Product / Process Change Notification (PCN)

<p>PCN #: PCN_IndCMBNC_20180818</p> <p>Affected Series: WE-CMBNC-Series 744801xx; 744803xx; 744804xx 744805xx; 744806xx; S16100084; S17100100</p> <p>PCN Date: May 18, 2018</p> <p>Effective Date: August 18, 2018</p>	<p>Change Category:</p> <p><input type="checkbox"/> Equipment / Location <input type="checkbox"/> General Data <input checked="" type="checkbox"/> Material <input checked="" type="checkbox"/> Process <input type="checkbox"/> Product Design <input type="checkbox"/> Shipping / Packaging <input type="checkbox"/> Supplier</p>
--	--

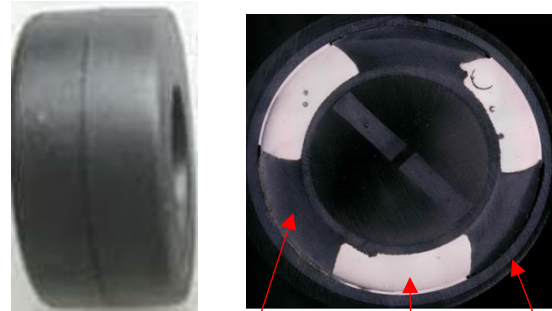
Before the change, the toroidal core was applied inside the plastic case and the two parts of the case were fixed together by one layer of tape. After the change, the tape will be removed and the toroidal core will be fixed inside the plastic case by silicone paste. It will be proceeded with 3 dots each core side, to fix the core to both parts of the case.

The new glue material will be silicone paste 9331 with UL File number: E306078. There will be no change in fit or function of the product.
